SUITE 407
ORIGINAL LAYOUT
INVENTORY SUITE

Suite 407
 * (INVENTORY SUITE)

NEW PLAN
 -REMOVED DEN
 -REVISED KITCHEN
 *REVISED LAUNDRY DOOR SWING &
 ENSUITE WALL AS PER THIS BROCHURE

SUITES 407 - NOYAC BAY (Inventory suite)

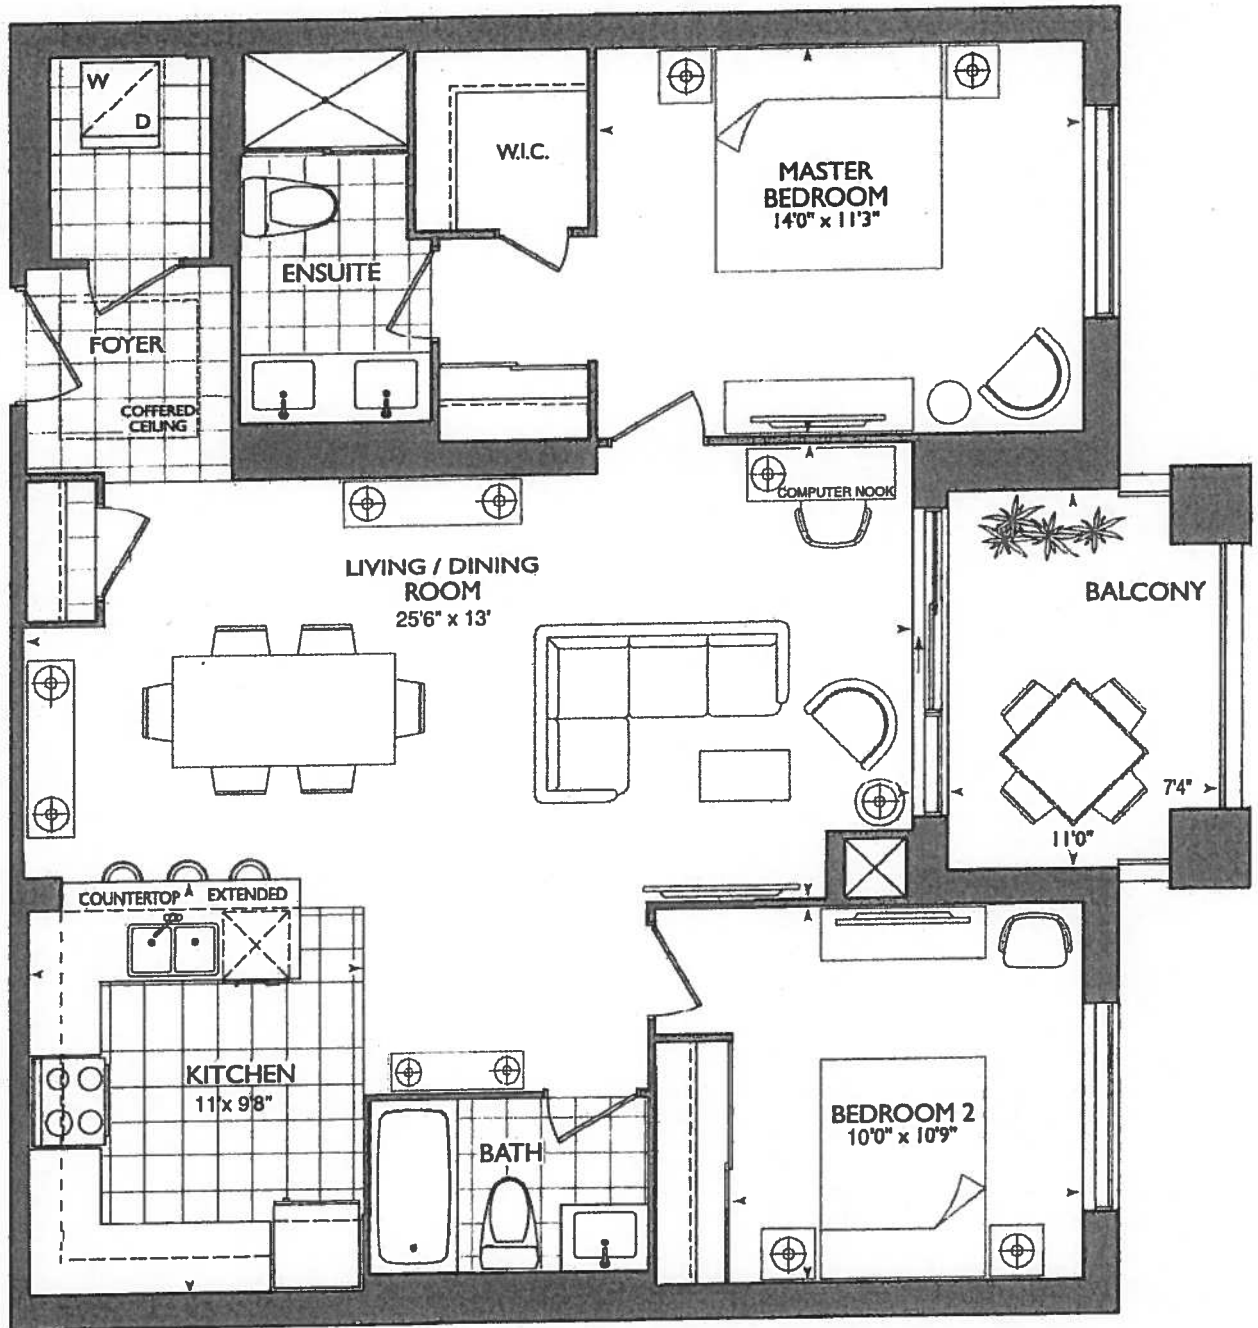
(NEW).

→ CONDUIT =

-(x2) CAPPED PENDANT
 -(x1) PLUG PENINSULA
 (x5) PUCK LIGHTS

• 65" STOVE PRE CENTER
 • 129" SINK PRE CENTER

* Revised Powder Room
 + Ensuite Vanity
 36 1/4" w/ 3" SPLASH

* LIVING Room
 Console / PUG / BLOCKING
 WALL MOUNTED
 T.V.

6" WALL
 BEHIND W/D

* KITCHEN *

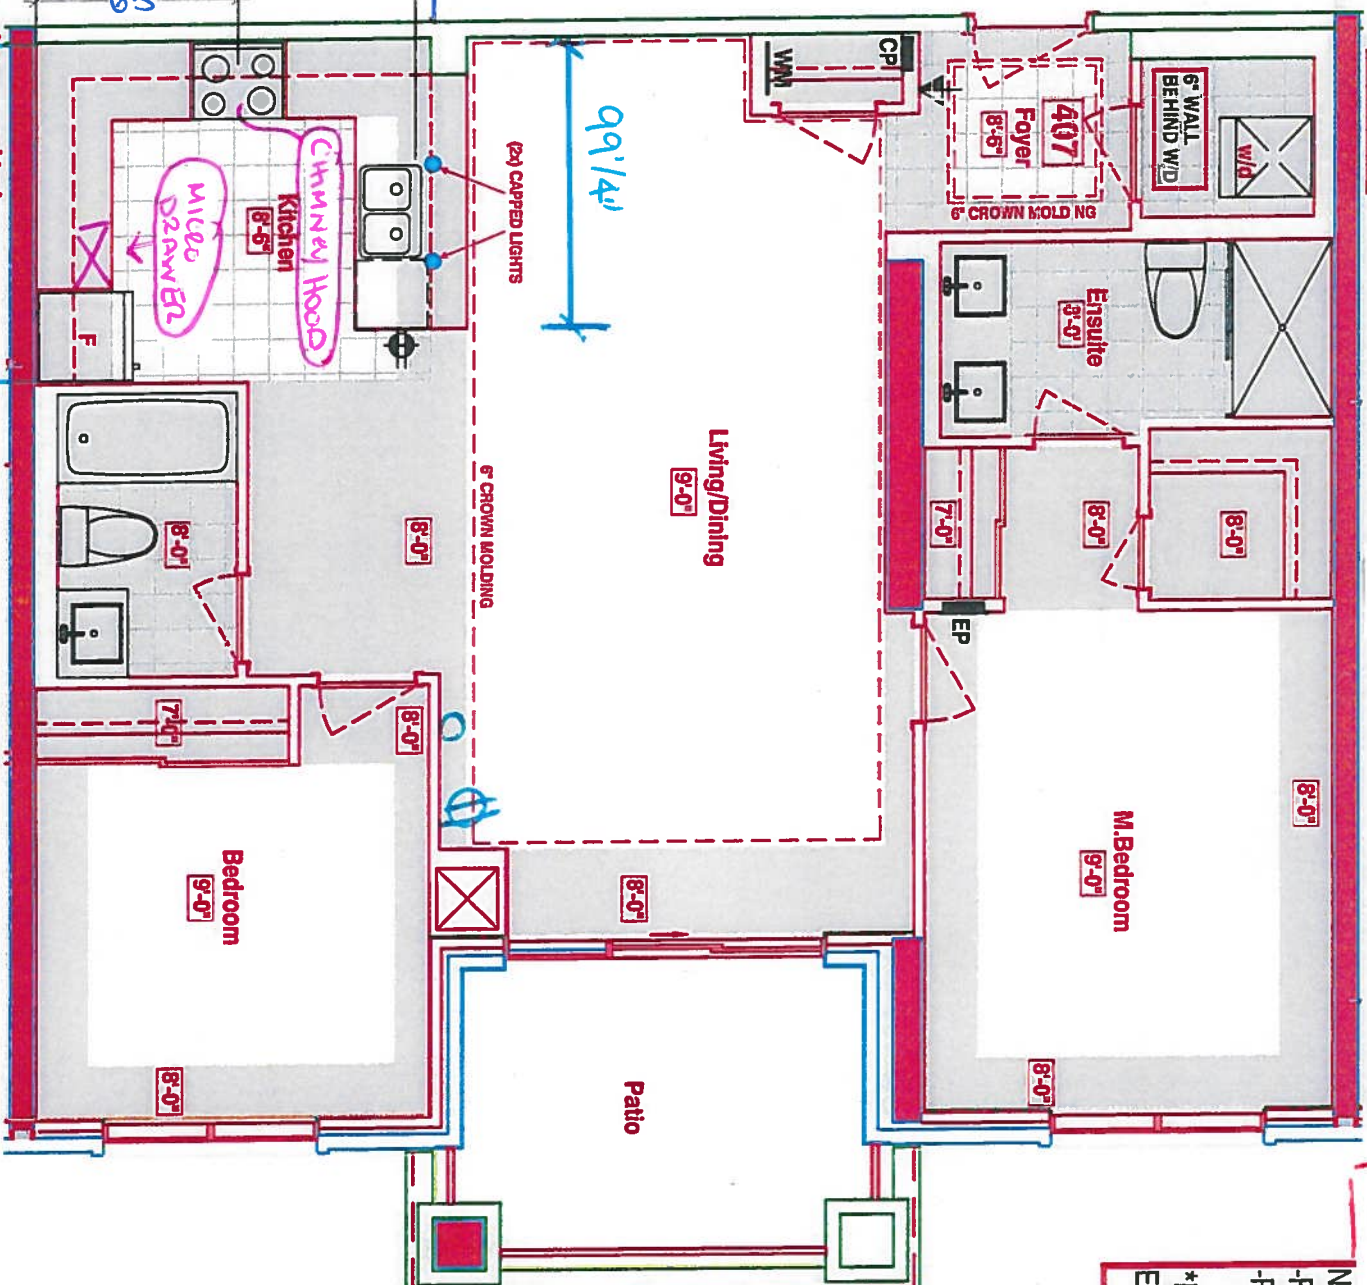
65"0 KITCHEN LAYOUT
 015-2UR6 APPLIANCE PKG
 w/ 36" REFRIG ⊕
 CHIMNEY HOOD FAN ⊕
 MISC DRAWER

POWDER ROOM

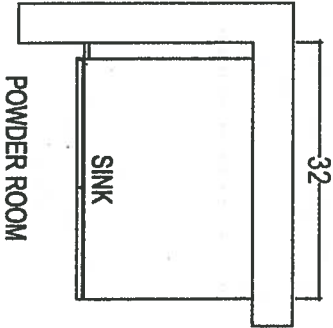
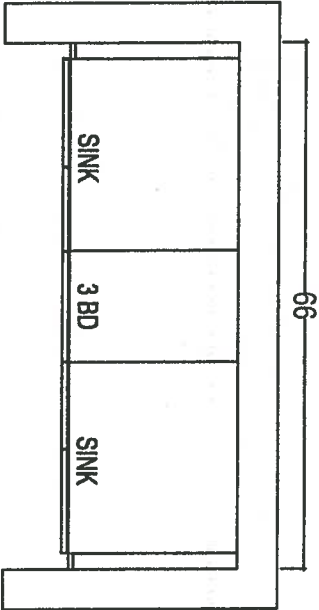
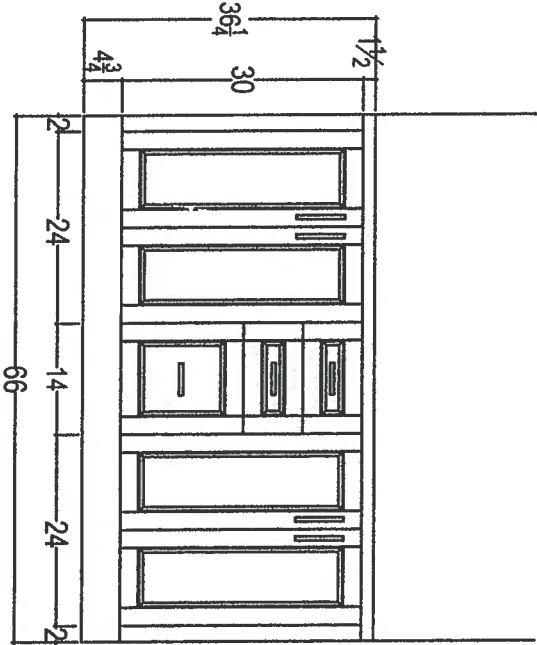
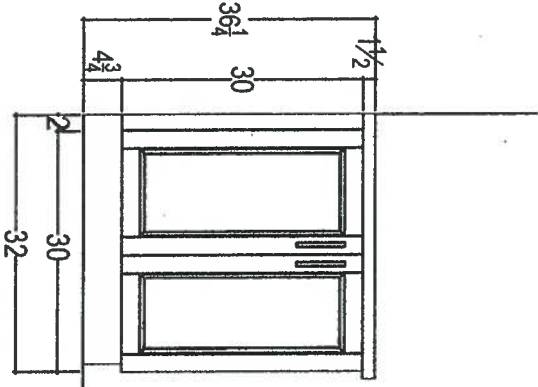
Ranso Vanities to 3" Solach.
